NOTICE OF PROPOSED CHANGE IN PROPERTY

Petition: x349

REQUEST ENCROACHMENT INTO CASS AT 4710 CASS AVE.
 (With Outdoor Seating and Canopies)

CITY OF DETROIT	
CITY ENGINEERING DEPARTMENT	
SURVEY BUREAU	
JOB NO.	01-01
DRWG. NO.	X 349

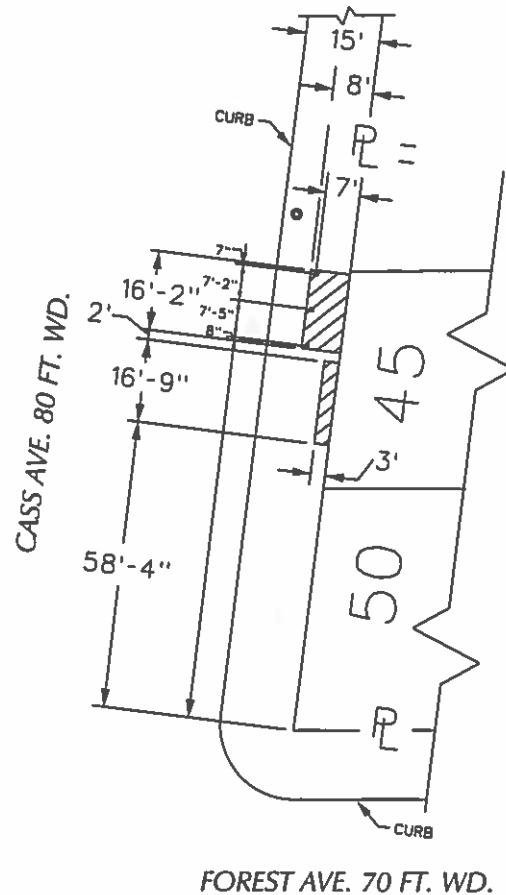
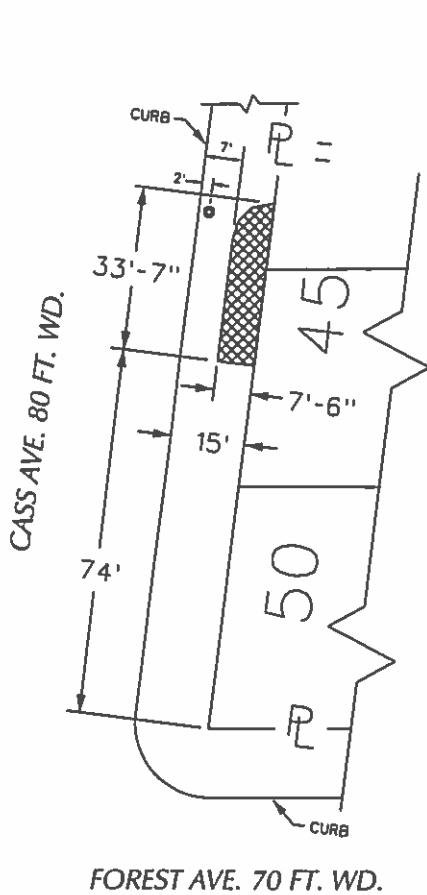
- Not Involved
- Involved; but asking you to hold action on this petition until further notice.
- Involved; but no objections to the property change.
A 6' unobstructed pedestrian clearance should be provided between the outdoor seating fencing and the existing light pole and parking kiosk. The Chief Operating Officer for the City of Detroit reserves the right to revoke approval. P&DD does not support a permanent encroachment and recommends a duration of 3-5 years.
- Involved; objection to the property change.
- Involved; but no objections to the property change...provided as easement of the full width of the public right-of-way (street, alley or other public place) is reserved.
- Involved; the nature of our services and the estimated costs of removing and/or rerouting such services are:
